**RE: REVIEW – ASSESSMENT REPORT FOR THE EVALUATION OF CONDITIONS IN THE REGIONAL AQUIFER
AROUND WELL R-70
LOS ALAMOS NATIONAL LABORATORY
EPA ID#NM0890010515
HWB-LANL-21-034**

**NMED TECHNICAL COMMENTS ON ASSESSMENT REPORT FOR THE EVALUATION OF
CONDITIONS IN THE REGIONAL AQUIFER AROUND WELL R-70, JUNE 30, 2021**

EXHIBIT 2
ADDITIONAL TECHNICAL COMMENTS

Aquifer Parameters Between PM-3 and R-35a

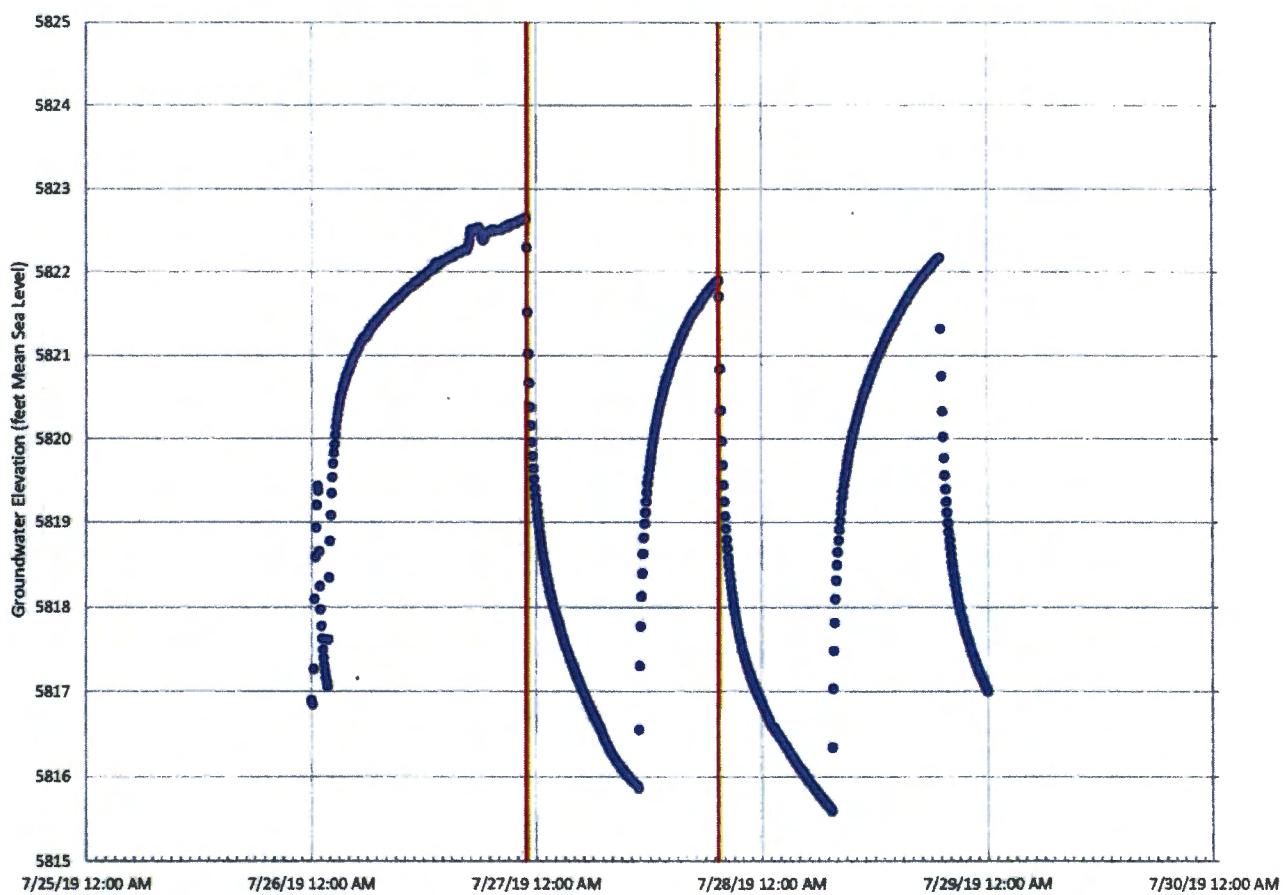
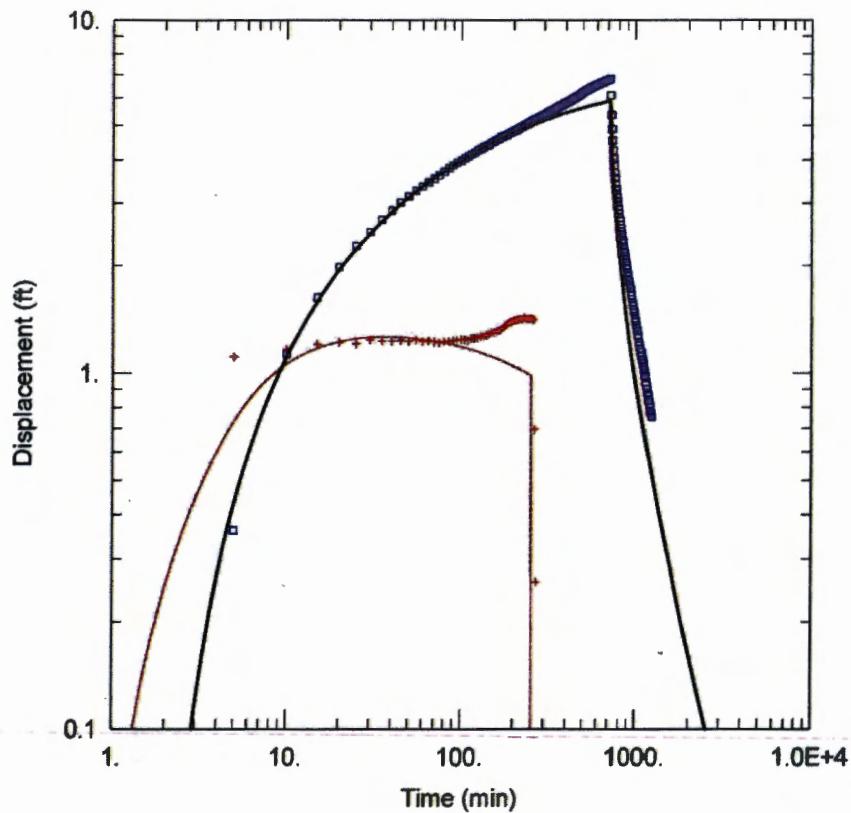
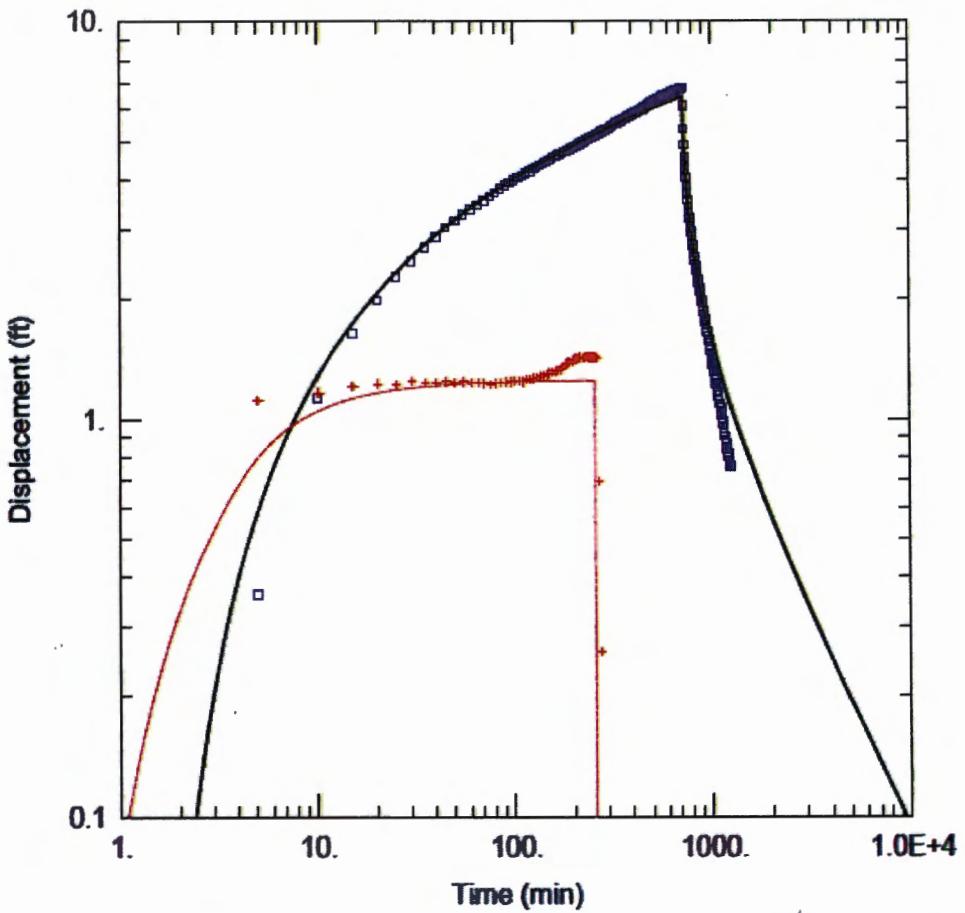
NMED Comment: NMED finds DOE's interpretation to be unsupported, specifically *"(Faint influences of PM-3 were possibly detected at R-35a, R-35b, and R-44 screen 2, but even at these locations, the effect was dwarfed by the influence of PM-2 and PM-4...)"*. The influence from PM-3 pumping on R-35a is not dwarfed by PM-2, PM-4, and O-4. To present a more plausible aquifer assessment, NMED performed tenable analyses on the effects that the July 27, 2019 PM-3 pumping operations had on the hydraulic head measured at regional aquifer monitoring well R-35a. NMED concludes that a substantial measured influence is consistently present and in a pronounced manner to perform an effective and tenable aquifer performance test between PM-3 and R-35a. The pumping is sufficient to be representative of the regional aquifer between PM-3 and R-35a, specifically the Chamita formation (Tcar) hydraulic properties.

NMED's analyses was performed using HydroSOLVE, Inc.'s AQTESOLV Professional version 4.5 aquifer test analysis software and is provided in Attachment 1 to Exhibit 1. NMED has determined that the aquifer transmissivity of the Tcar is about 18,500 square feet per day, a storativity of 0.0015 and hydraulic conductivity of 78 feet per day when modeled as an unconfined system. NMED also considered a confined model due to the lack of a similar hydraulic response at R-35b, certain unconfined solution parameter limits being reached during convergence of the unconfined model, and a potential localized unsaturated/confining layer at a depth of 929 feet at PM-3. In the confined analysis, NMED used a thickness of 176 feet (thickness of Tcar between 929-foot anomaly and the top of the Miocene basalt) to derive appropriate aquifer parameters. The confined model analysis resulted in a transmissivity of 17,500 square feet per day, a storativity of 0.0009, and a hydraulic conductivity of 99 feet per day for the Tcar portion of the regional aquifer, which is more than an order of magnitude greater than the analysis shown in Figures 2.2-1 through 2.3-3 of the Report.
